TECHNICAL SERVICE BULLETIN

6.2L/7.3L - Illuminated MIL With DTCs P0132, P0135, P0138, P0141, P0152, P0155, P0158 And/Or P0161 - Built On Or Before 05-Jun-2020

20-2380

29 October
2020

Figure 1

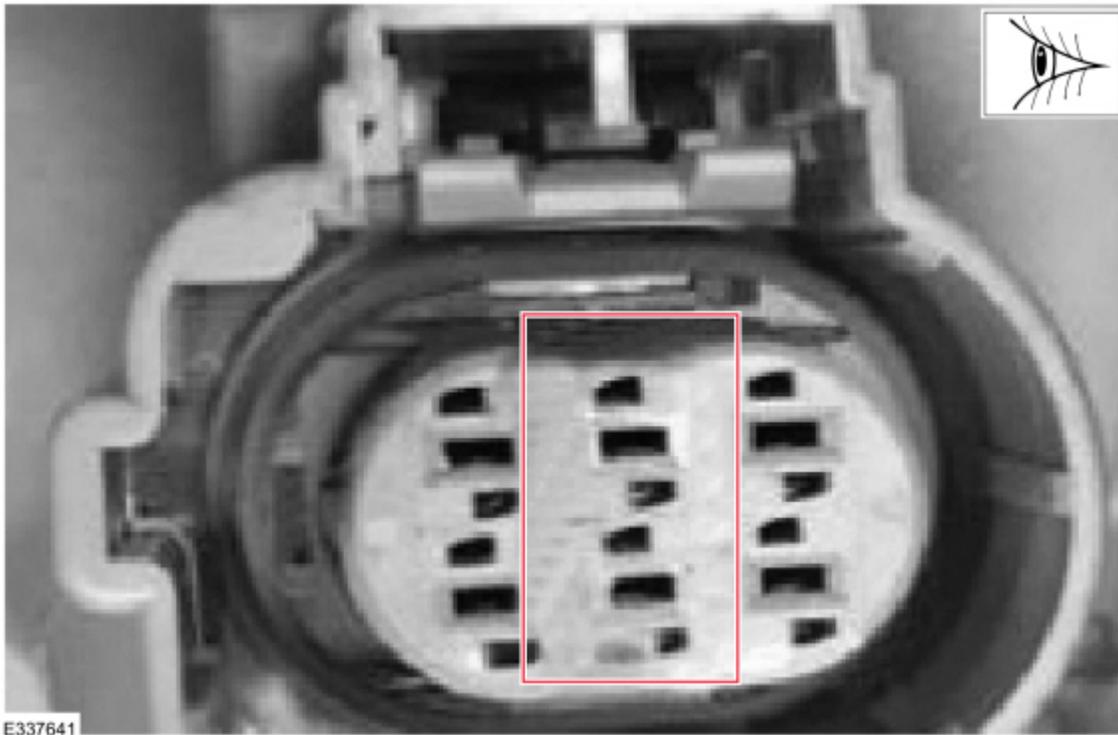
1. Disconnect the appropriate HO2S and/or the catalyst monitor sensor based on the DTC(s) received and inspect for moisture and/or corrosion on the pins of the sensor or the wiring harness. Are there any signs of moisture and/or corrosion present? (Figures 1-2)
 - (1). Yes - replace the affected HO2S and/or the catalyst monitor sensor. Refer to Workshop Manual (WSM), Section 303-14. Proceed to Step 2.
 - (2). No - this article does not apply. Refer to the Powertrain Control and Emissions Diagnosis (PC/ED) Manual for normal diagnostics.
